**Technical Service
Information Bulletin**

Title:
DOOR WOOD TRIM PANEL VIBRATION

Models:
'02 – '04 SC 430

NVH
NV002-04

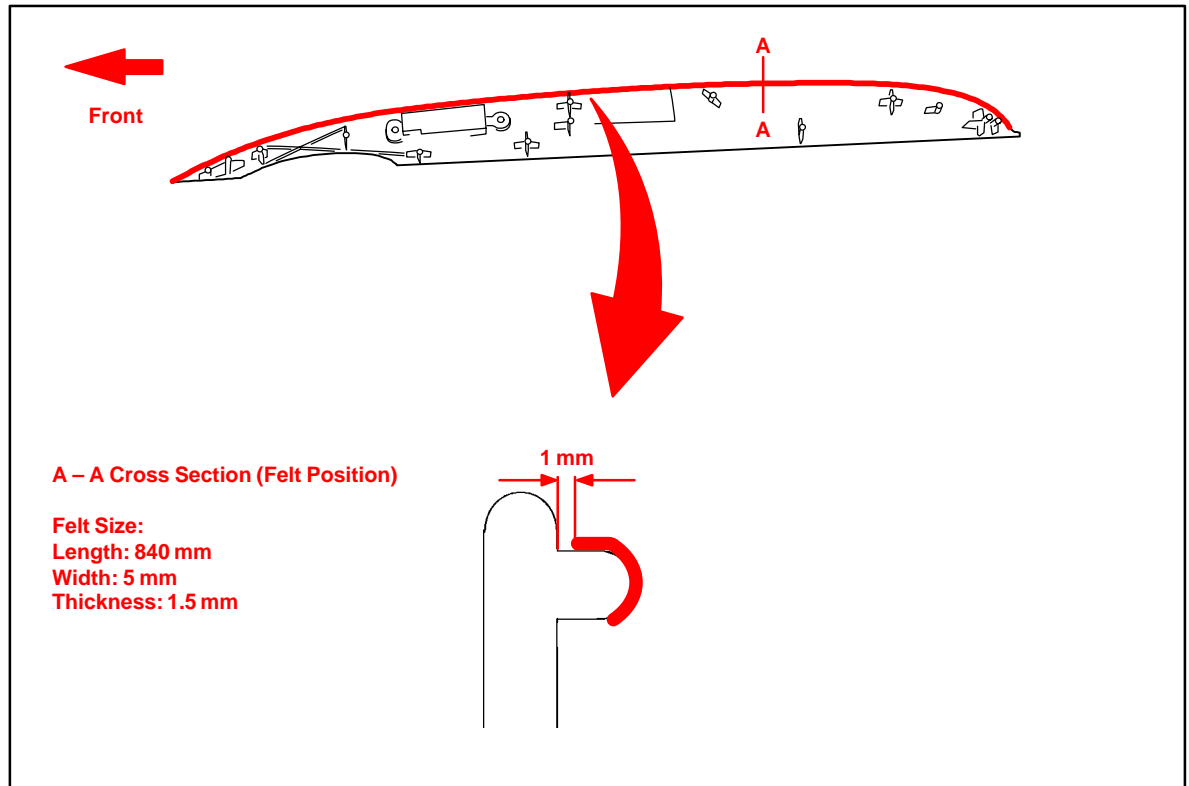
6. Fit a felt piece to the ornament as shown in the illustration (red portion).

Felt Size:
Length: 840 mm
Width: 5 mm
Thickness: 1.5 mm

- If 1.5 mm thick felt material is not available, layer multiple pieces to obtain the correct thickness.
- If felt material is shorter or longer than the following ornament length, patch multiple pieces together or cut the felt.

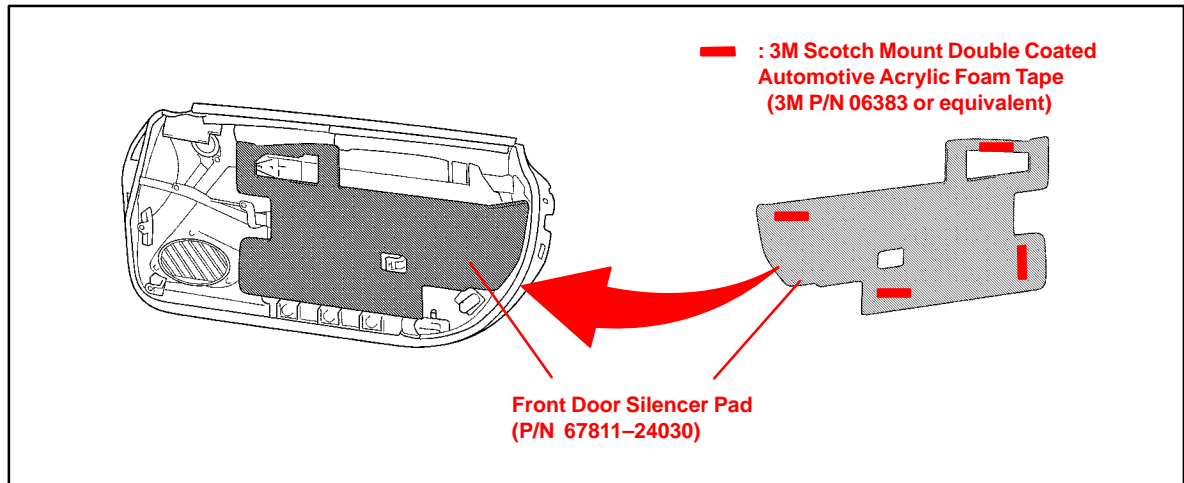
8. Cut and combine pieces of 3M Scotch Mount Double Coated Automotive Acrylic Foam Tape (3M P/N 06383) to create 4 sections with the following dimensions:

LENGTH	WIDTH
50 mm	30 mm

9. Apply each section to the new front door silencer pad (P/N 67811–24030) as shown in the illustration below.
10. Install new front door silencer pad to the reverse side of the inner door trim panel sub–assembly as shown in the illustration.
